Subject: **BSPP RESPONSE TO ALUC COMMENTS OF MARCH 22, 2010 ON ALUC APPLICATION AND SUBSEQUENT CORRESPONDENCE BY EMAIL ON APRIL 13, 2010**
BSPP RESPONSE TO ALUC COMMISSION COMMENTS FROM MAY 13, 2010 COMMISSION MEETING
DOCKET NO. (09-AFC-6)

BLYTHE SOLAR POWER PROJECT (09-AFC-6) RESPONSE TO ALUC COMMISSION COMMENTS FROM MAY 13, 2010 COMMISSION MEETING	
Page 1	Response Date: May 27, 2010

**Figure 1
 Topography**

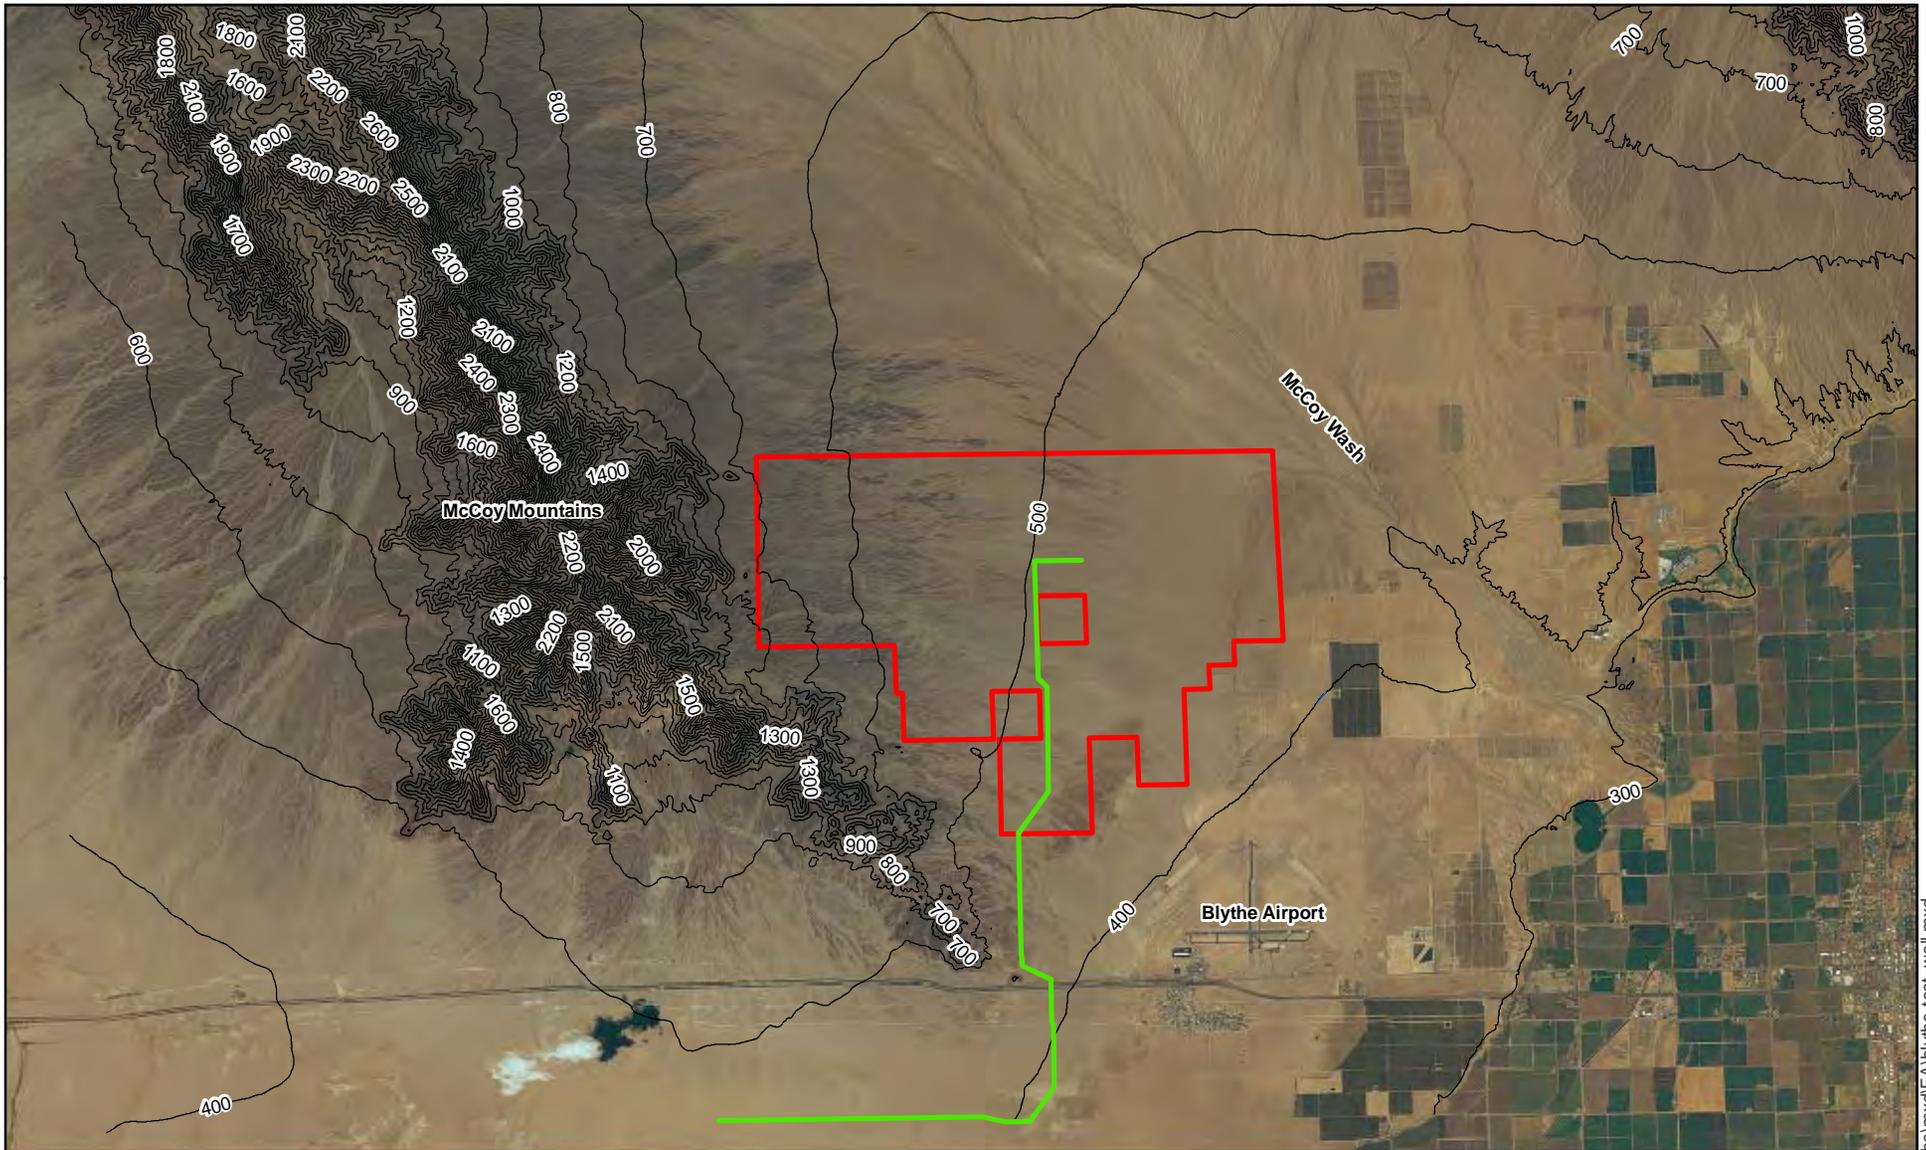
Please provide a topographic map showing the terrain in the vicinity of the Blythe Solar Power Project (BSPP) and the revised Generation Tie (GenTie) transmission line route to the Southern California Edison (SCE) substation.

Two topographic figures were prepared that show the terrain in the vicinity of the proposed BSPP and revised GenTie route. Figure 1 is a topographic map showing terrain contours in relation to the facility right of way (ROW) and the revised GenTie route. Figure 2 is an approximate pilot view of an approach to Runway 26 consisting of a pseudo 3-dimensional plot of terrain elevations, overlaid with the airport compatibility zones, the project ROW, and the revised GenTie route.

Figure 3
Project Disturbed and
Open Space in Zone D

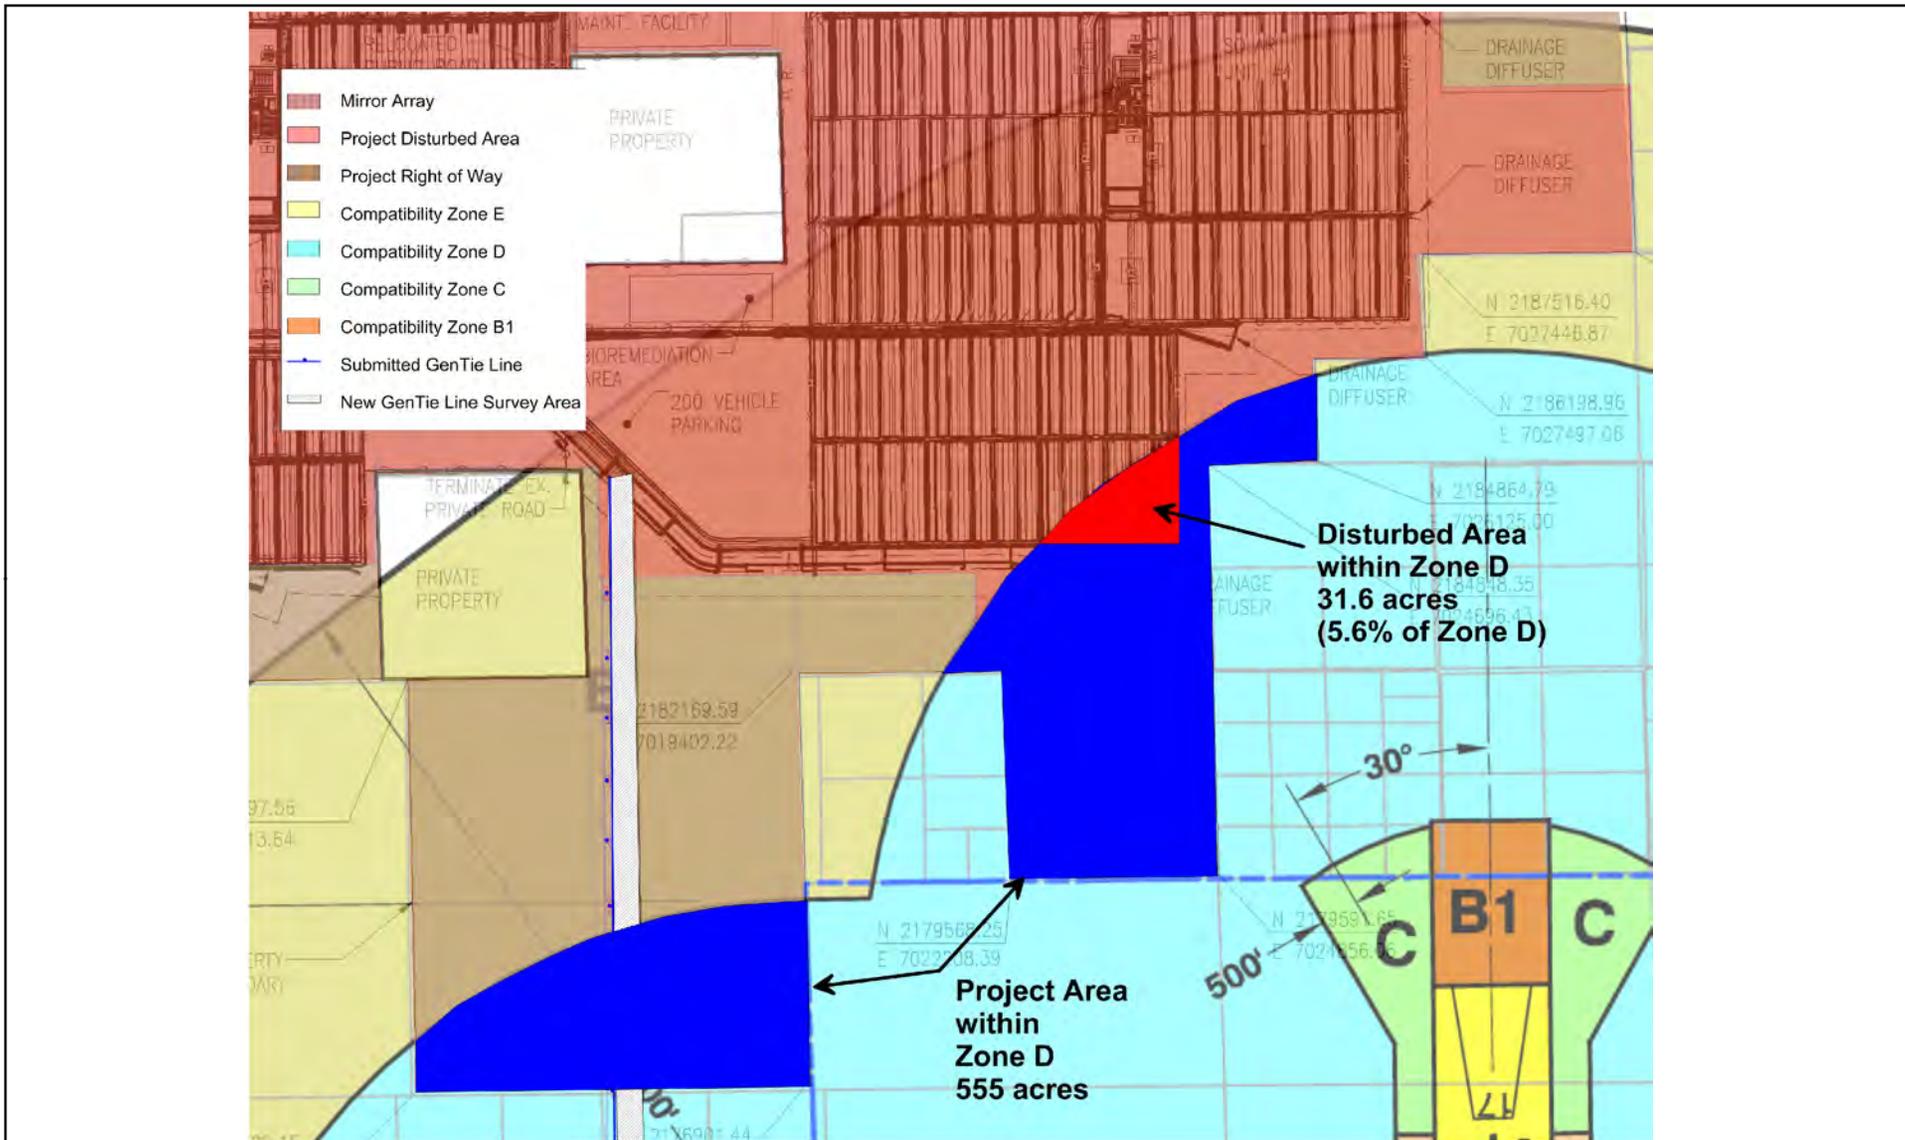
Confirm the closeout of the open-space issue in Zone D.

The Applicant understands that the issue of the amount of open space in that portion of the project within Compatibility Zone D had been addressed to the satisfaction of the Commission Staff. To reiterate, that portion of the disturbed project within the Airport Influence Area Zone D where solar mirrors will be located comprises 31.6 acres, or 5.6 percent of the total project area within Zone D. Thus, the open space within Zone D is 94.4 percent, compared with the open space required by the ALUC of at least 10 percent. Figure 3 below presents a plot of the BSPP open space and built space within the area defined as Zone D.

Figure 5
Blythe Airport Estimated
Future Right Hand Turn Pattern
for Runway 26
(Approximately 80% of Traffic)

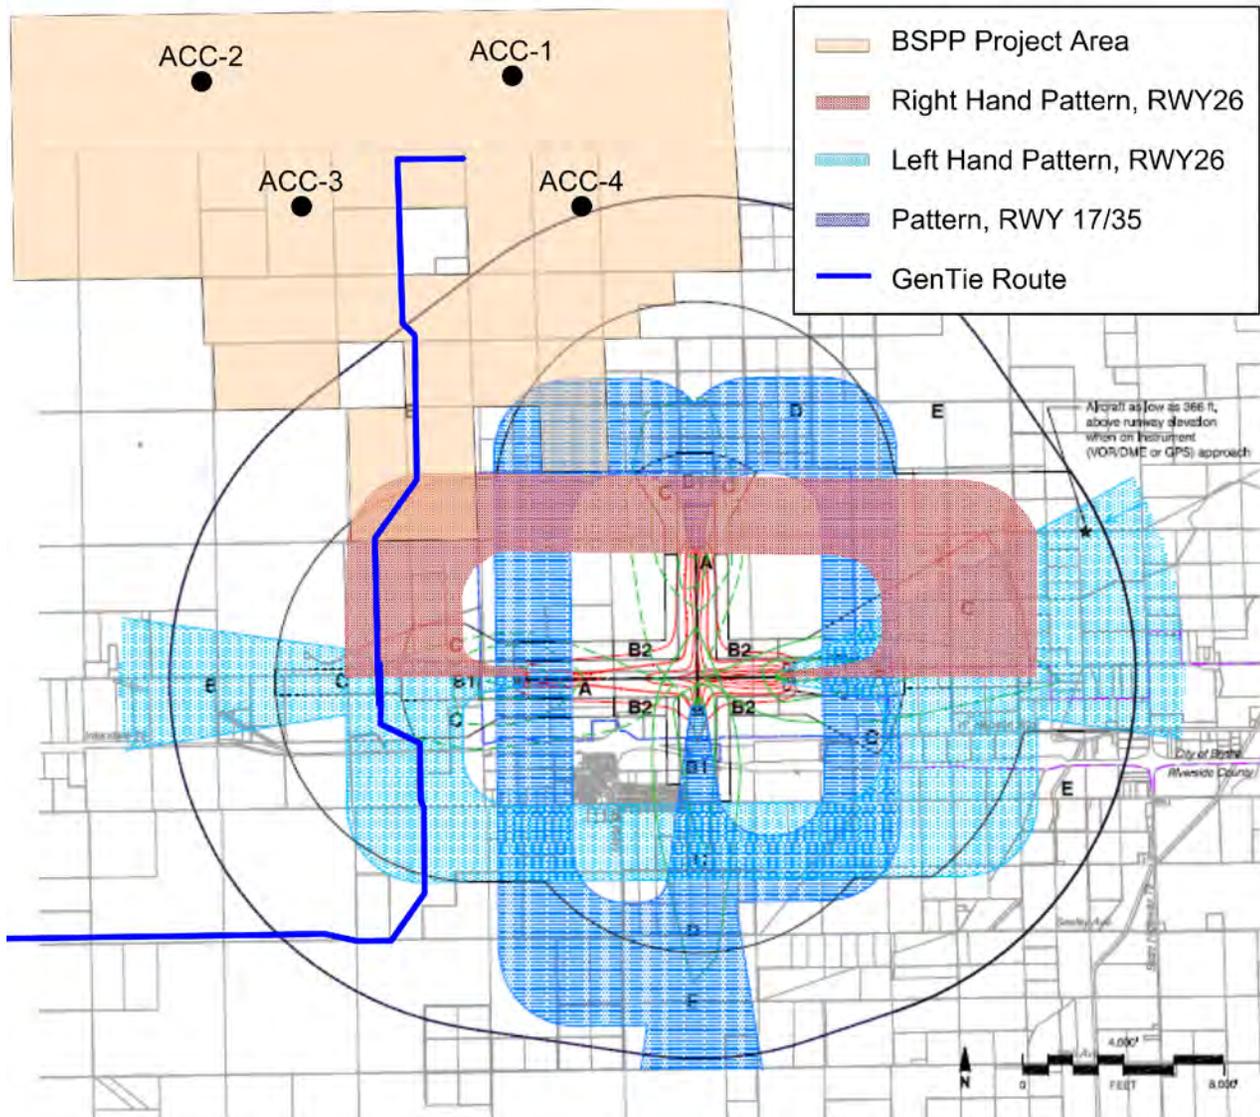
Please supply a figure of the proposed right hand pattern for Runway 26 and the potential for the Blythe II Notice to Airmen (NOTAM)/mitigation to cause pilots to overfly an Air Cooled Condenser on the project site.

The Riverside County Airport Land Use Compatibility Plan, Volume 3 Blythe Airport, Exhibit BL-7, contains a drawing of the estimated limits of the traffic pattern at the Blythe Airport. The exhibit reflects the 80th percentile file profile in that 80 percent of all traffic is expected to occur within the delineated bounds for the pattern. To approximate the 80th percentile for a right hand traffic pattern, a mirror image of the left hand pattern was created and placed on top of the Compatibility Plan figure. This new plot is presented in Figure 5. It is clear from the plot that the ACC-4 is well outside the traffic pattern. By scaling from the figure, the ACC-4 is approximately 10,400 feet from the outer edge of the right hand traffic pattern at its nearest point, and 24,400 feet from the inner edge of the left hand pattern. Therefore, the potential NOTAM/mitigation for the Blythe II project resulting in a right hand turn pattern for Runway 26 will not cause pilots to overfly the ACC-4. Because the existing and proposed future traffic patterns for the Blythe Airport do not take pilots near any of the project's ACCs, the only way any pilot would fly over an ACC is if the pilot directed the aircraft to purposely fly over the ACC. For pilots following the normal patterns, BSPP does not have an impact on the airport operations.

**Figure 6
Horizontal Projection of
Sun's Rays and Reflection Rays,
for June 21 and April 10**

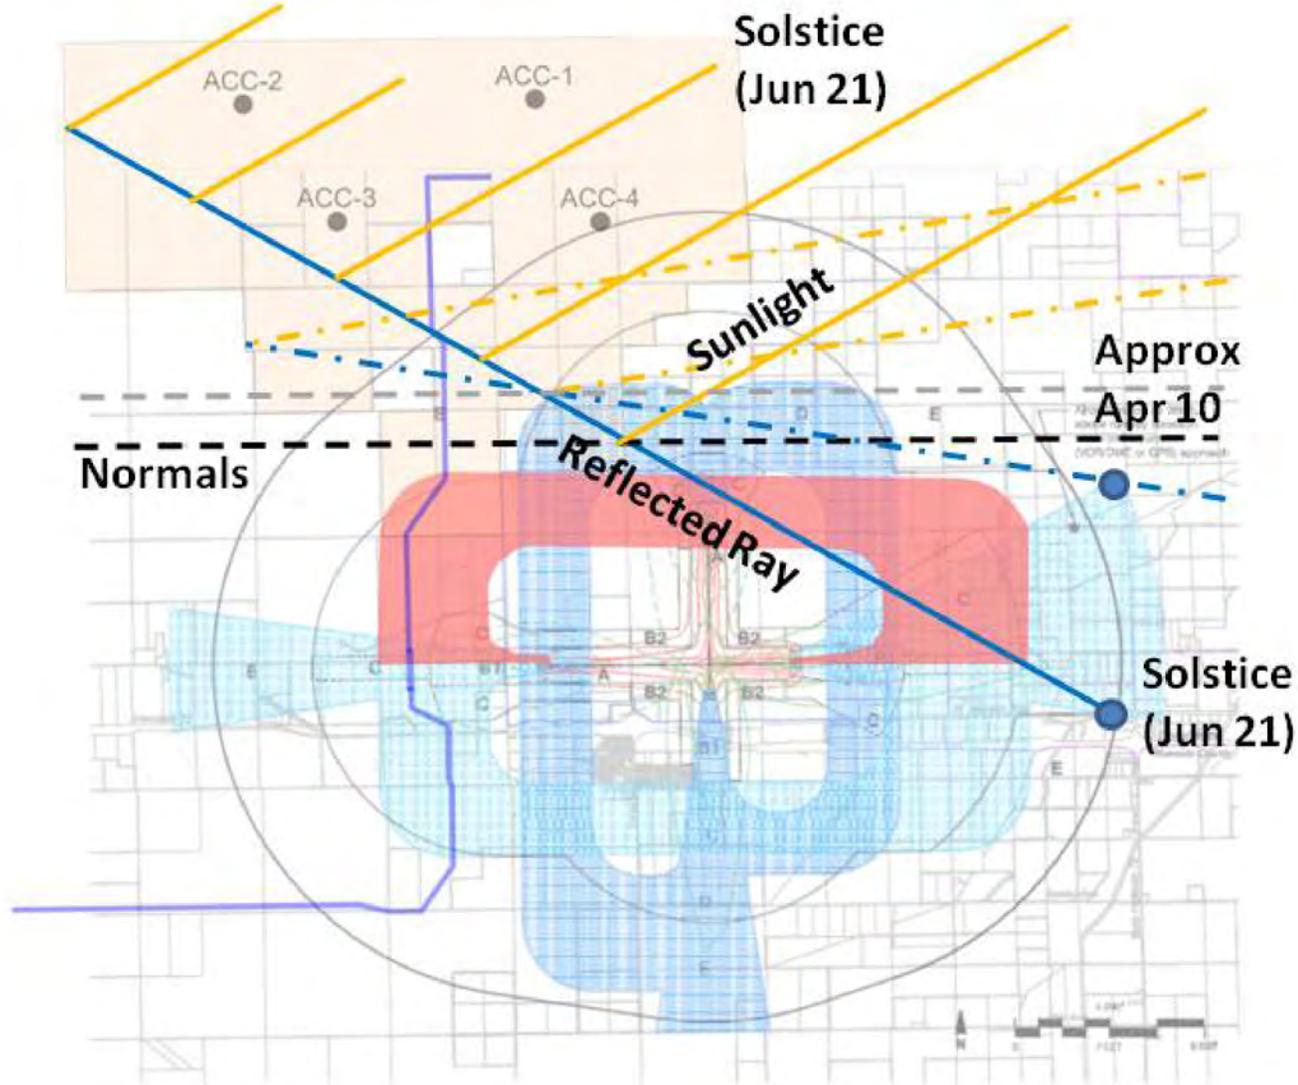
Please determine whether it would be possible and – if so, at what times of day and seasons of the year – for reflection, glint, or glare from any element of the solar array to intersect Runway 26 or its centerline extended easterly at a height of 1000 feet or less above ground level. Presumably, this would be most likely to occur on the summer solstice, but you may need to check other dates if Snell's Law results in this having a greater probability of occurring at other times. The concern is the potential for a flash or beam of light that would affect a pilot on a final approach to a landing on that runway (coming from east and making a westbound landing).

no direct reflection of the sunlight from the mirror surface involved in this postulated scenario. The postulated reflection will occur off of the metallic joints in the HCE tube and reflection by the glass surface. Due to curvature in the joint and HCE tube, only a small portion of the surface will be involved in the reflection to a given viewpoint. According to Snell's law, the incident and reflected light must be in the same plane and form equal angles with respect to the normal to the HCE tube (due east, or 90° azimuth because of the north-south alignment of the HCE tubes). The summer solstice will produce the worst-case geometry because the sun is at its northern most extent on the solstice, which will maximize the incident and reflected angle with respect to the normal, thereby maximizing the area in which the postulated reflection could potentially be seen. Figure 6 provides a plan view of the postulated reflection scenario while Figure 7 presents a side view.

The above geometry reflects 6:00 AM PDT on June 21 at Blythe. The solar elevation angle is 5 degrees above the horizon and the solar azimuth is 65 degrees clockwise from north. Any reflection along the HCE tube will be directed downward and will strike the ground within a short distance. Such a reflection will not be visible from the air.
